Subject: UniStar Nuclear Energy, NRC Docket No. 52-016  
Response to Request for Additional Information for the  
Calvert Cliffs Nuclear Power Plant, Unit 3,  
RAI No. 204, Potable and Sanitary Water Systems

**Response to NRC Request for Additional Information  
RAI No. 204, Question 09.02.04-1, Potable and Sanitary Water Systems  
Calvert Cliffs Nuclear Power Plant, Unit 3**

**Question 09.02.04-1**

Figure 9.2-1—(Potable Water System)

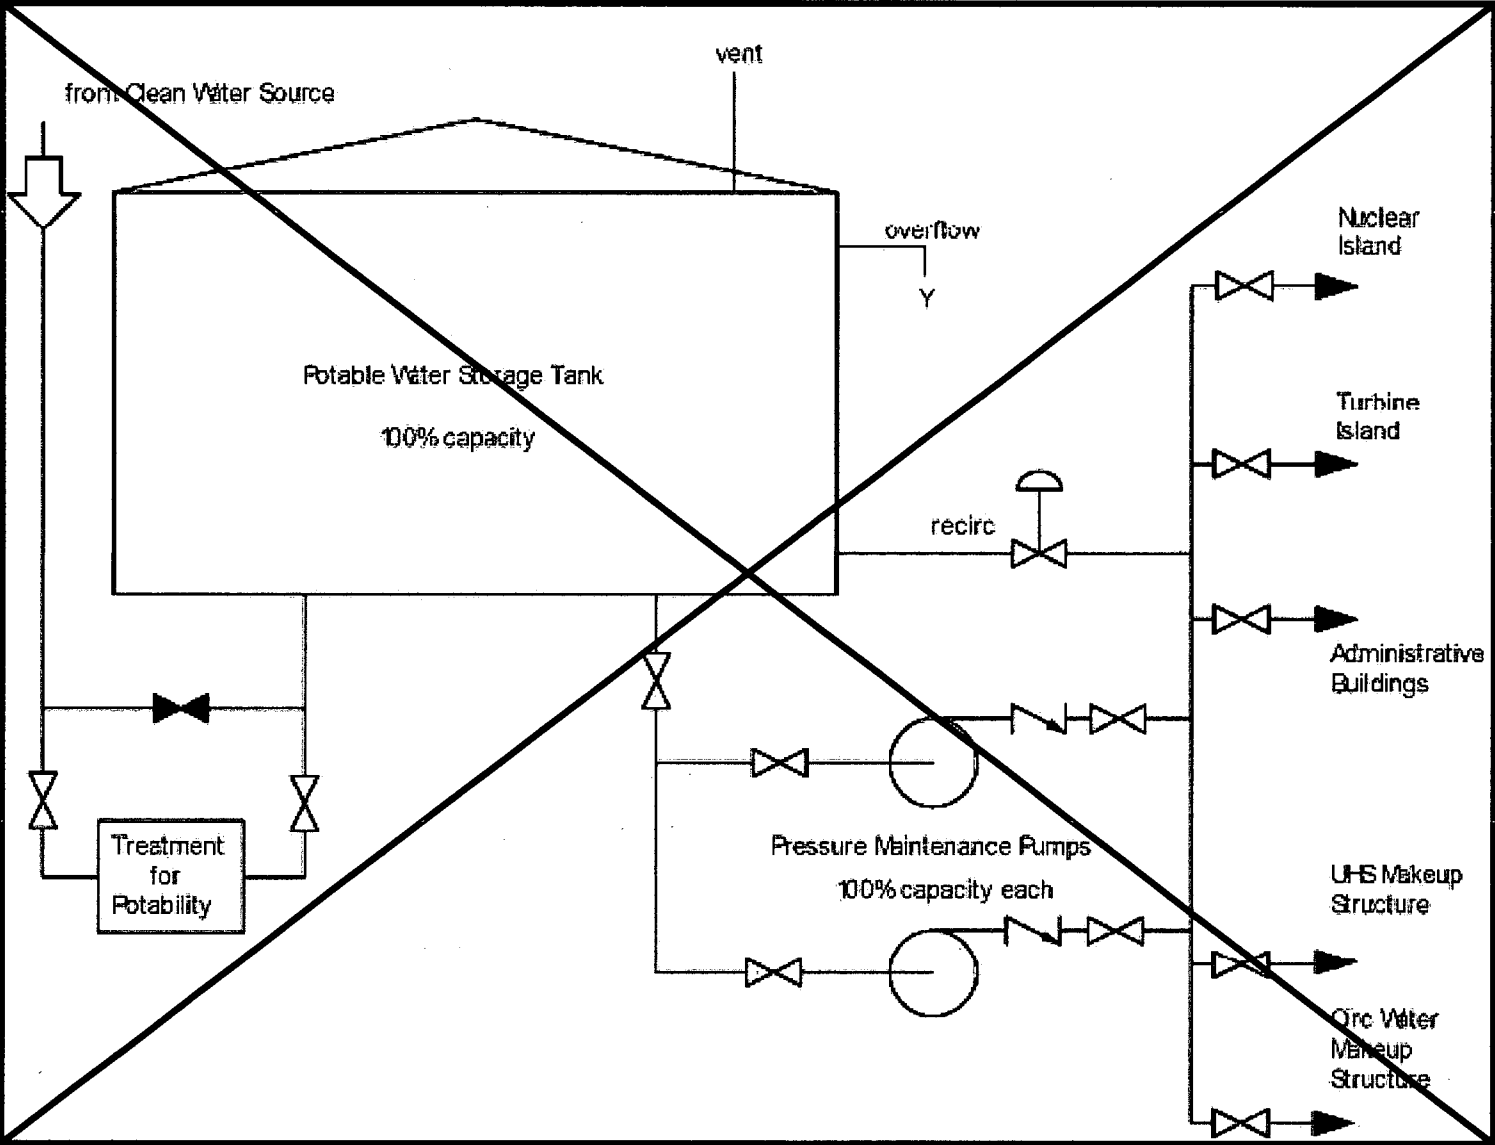
CCNPP-3 FSAR Tier 2, Rev. 6, Section 9.2.4 and Figure 9.2-1 present information on the potable water supply system and describe features that are used to ensure that the system is not connected to radioactive systems in order to prevent the possibility of unmonitored and uncontrolled radioactive releases. The design features include backflow preventers, siphon breakers and air gaps, and application of differential system pressures. While the staff finds these features consistent with the requirements of Part 20.1406, GDC 60 of Appendix A Part 50, and IE Bulletin 80-10, a review of FSAR Figure 9.2-1 indicates that a feature of the design includes a recirculation loop, with an isolation valve used to separate the potable water system from other plant systems servicing the nuclear power block. The safety evaluation described in CCNPP-3 FSAR Section 9.2.4.3 does not address the types of administrative control measures that will be applied to ensure that the need for recirculation is justified and that the opening of the recirculation valve is controlled to avoid inadvertent openings and that other plant systems are isolated from the potable water system during recirculation. The applicant is requested to revise the safety evaluation of the potable water system described in CCNPP-3 FSAR Section 9.2.4.3 by providing information that describes administrative control measures and/or additional design features that will ensure that the potable water system does not become contaminated whenever the system is being recirculated. (Note: A review of FSAR Figure 9.2-1 indicates that the recirculation valve and check valve/backflow preventer P&ID symbol legends are not consistent with that presented in U.S. EPR FSAR, Tier 2, Rev. 1, Figure 1.7-1. It is recommended that as part of this RAI, the applicant makes the necessary corrections to CCNPP-3 FSAR Tier 2, Figure 9.2-1 to ensure consistency in the depiction of system components.)

FSAR Figure 9.2-1, Potable Water System, will be revised to clarify the depiction of the recirculation line for each transfer pump and to note the presence of backflow prevention devices at each building connection requiring potable/sanitary water. In addition, as stated in Section 9.2.4.3, Safety Evaluation, backflow preventers are provided at "hard" connections to specific components or systems in certain areas of the plant (i.e., in radiologically controlled areas) to further prevent backflow under abnormal, reversed differential pressure conditions.

The revised Figure 9.2-1, which includes the update to the symbol for the check valves shown downstream of the transfer pumps, is in compliance with the U.S. EPR FSAR Figure 1.7-1, P&ID Symbol Legend. [Note: As explained in Note 1 of revised Figure 9.2-1, the check valves shown on revised Figure 9.2-1 are not the backflow prevention devices discussed in CCNPP Unit 3 COLA, Rev. 6, Section 9.2.4.]
